**TECHNICAL BULLETIN**

**412CF-17-109**  
21 February 2017

**MODEL AFFECTED:** 412CF

**SUBJECT:** NEW TAIL ROTOR BLADE P/N 412-016-100-115,  
INTRODUCTION OF.

Figure 1 (Sheet 1 of 2)

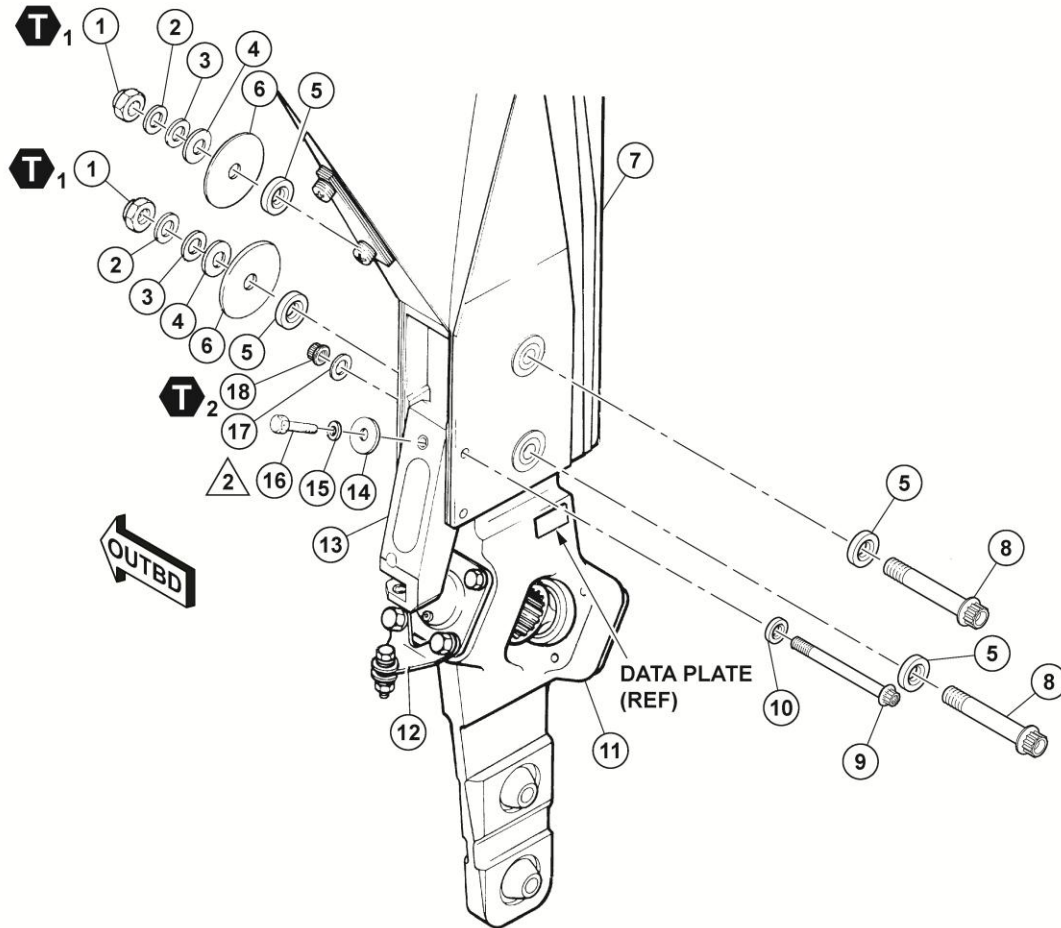
4. Re-assemble the tail rotor hub and blade assembly with the new tail rotor blades and hardware as per Figure 1 and BHT-412-CR&O, Chapter 64.

Blade retaining bolts and pitch horn retaining bolts have different torques than previous bolts. Refer to Figure 1 and BHT-412-CR&O, Chapter 64 for the proper torques.

1 45 TO 54 FT-LBS  
(61 TO 73 Nm)

2 130 TO 150 IN-LBS  
(14.7 TO 17.0 Nm)

1. During reassembly reuse existing hardware except where new part number is listed.
-  2 Use required length of bolt (NAS6604H1 through NAS6604H10) as determined during static balance procedure, refer to BHT-412-CR&O.
